Access Compliance Report

Public Rights-of-Way

(Curb Ramps)

Intersection ID: 10032672	Main Street: N_KINGS_DR	Cross Street: N/A	Location: S
ADA ID: 3221CA4BB3DC	Ramp Type: PerpDiag	Initial Pass/Fail: Fail	Overall Compliance: No
		Severity Score: 8.75

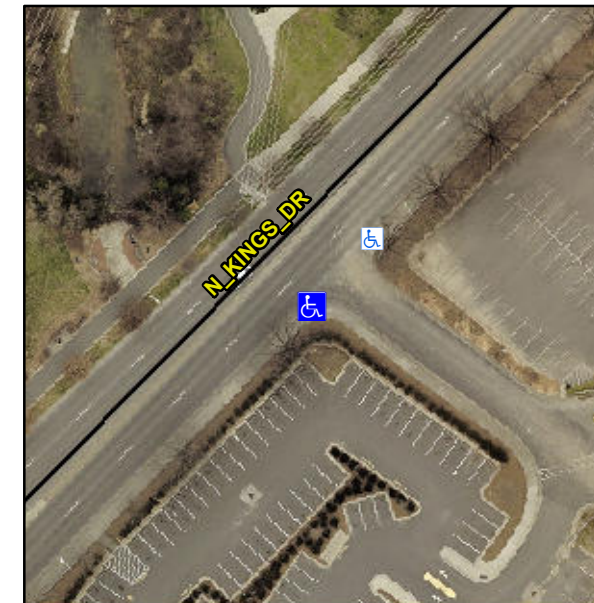
Not Found, R304.5.1

Remove & Replace Curb Ramp With Two New Directional Ramps or Equivalent.
